Operation Alert #: 197

MODEL AFFECTED: S-20 & S-21 equipped w/ ROTAX 916iS

Subject:

The images below show the RANS supplied hose/clamp coming loose from the ROTAX pop off valve.

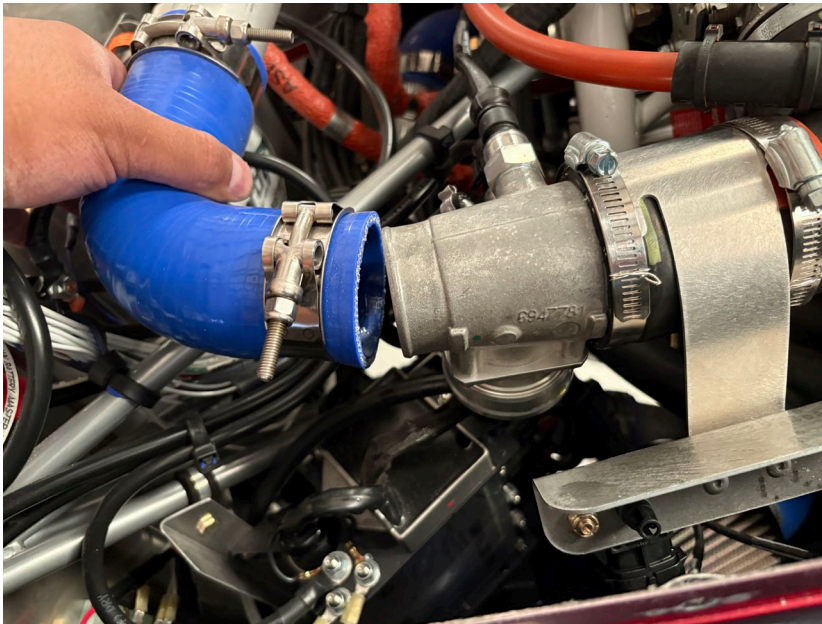
RANS has received a few field reports indicating instances where turbocharger hoses have detached under high engine load. Specifically, hoses have separated from the ROTAX pop-off valve and, in one case, from the aluminum Intercooler Connecting Tube (KPPW0397).

The currently installed T-Bolt Clamp (KSHW0128) has been determined to be too wide for the recessed groove on the ROTAX pop-off valve. To ensure proper seating and retention, replace this clamp with:

- **KSHW0129 — 50–70 mm Hose Clamp, 9 mm band width**
